## SOLICITATION AMENDMENT MODIFICATION DE L'INVITATION

<b>Title - Sujet</b> VENTILATION TOWERS REHABILITATION	
<b>Solicitation No. - N° de l'invitation</b> EP748-141813/A	<b>Amendment No. - N° modif.</b> 013
<b>Client Reference No. - N° de référence du client</b> 20141813	<b>Date</b> 2014-04-10
<b>GETS Reference No. - N° de référence de SEAG</b> PW-\$\$\$FG-356-64724	
<b>File No. - N° de dossier</b> fg356.EP748-141813	<b>CCC No./N° CCC - FMS No./N° VME</b>
<b>Solicitation Closes - L'invitation prend fin</b> <b>at - à 02:00 PM</b> <b>on - le 2014-04-15</b>	<b>Time Zone</b> <b>Fuseau horaire</b> Eastern Daylight Saving Time EDT
<b>F.O.B. - F.A.B.</b> <b>Plant-Usine:</b> <input type="checkbox"/> <b>Destination:</b> <input checked="" type="checkbox"/> <b>Other-Autre:</b> <input type="checkbox"/>	
<b>Address Enquiries to: - Adresser toutes questions à:</b> Lagacé, Hélène	<b>Buyer Id - Id de l'acheteur</b> fg356
<b>Telephone No. - N° de téléphone</b> (819) 956-0060 ( )	<b>FAX No. - N° de FAX</b> (819) 956-8335

**This amendment is being raised to:**

## **ADDENDUM 6**

PROJECT PROJECT NO. R.008227.002 PROJET NO. R.008227.002		DRAWING TITLE DRAWING E7 DETAIL 3 - SENATE TOWER - SECOND FLOOR DESSIN E7 DETAIL 3 - 2IÈME ÉTAGE - TOUR DU SÉNAT	
	BPA PROJECT # 8010-135	DRAWN A.L.W.	SCALE 1:50	DRAWING NUMBER  <b>SKE-E2</b>
	DATE 28/03/2014	CHECKED	REVISION 00

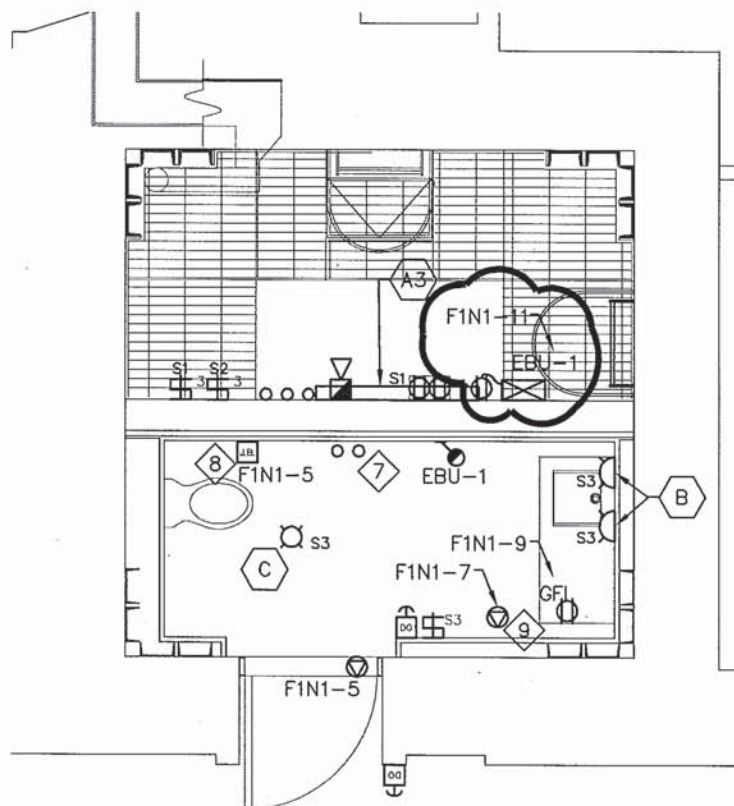
**DELETE**      SKE-E1

**ADD**          SKE-E2
